REMARKS

Final OA Resp

Fig. 1A.

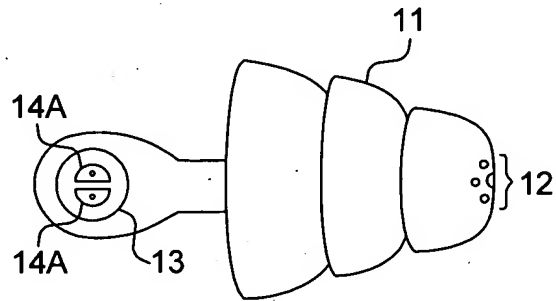
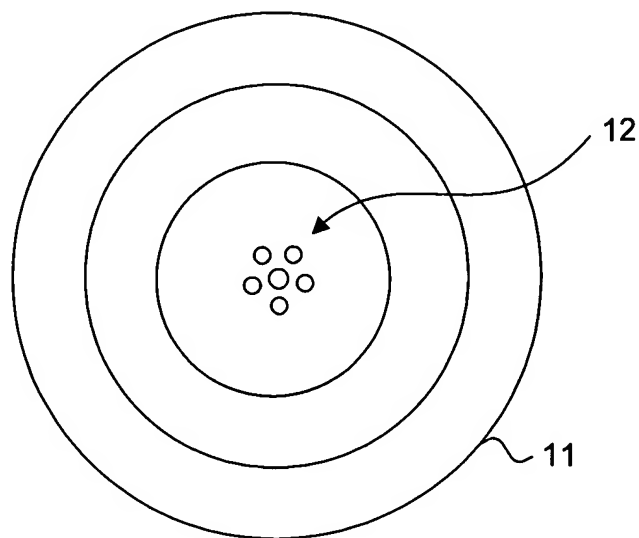
5 The drawings stand subject to objection under 37 CFR § 1.84(p)(4). FIGURE 1 has been amended per the Examiner's suggestion. A complete set of replacement drawings, consisting of three (3) sheets of drawings, are included with this response. No new matter has been added. Withdrawal of the objection is respectfully requested.
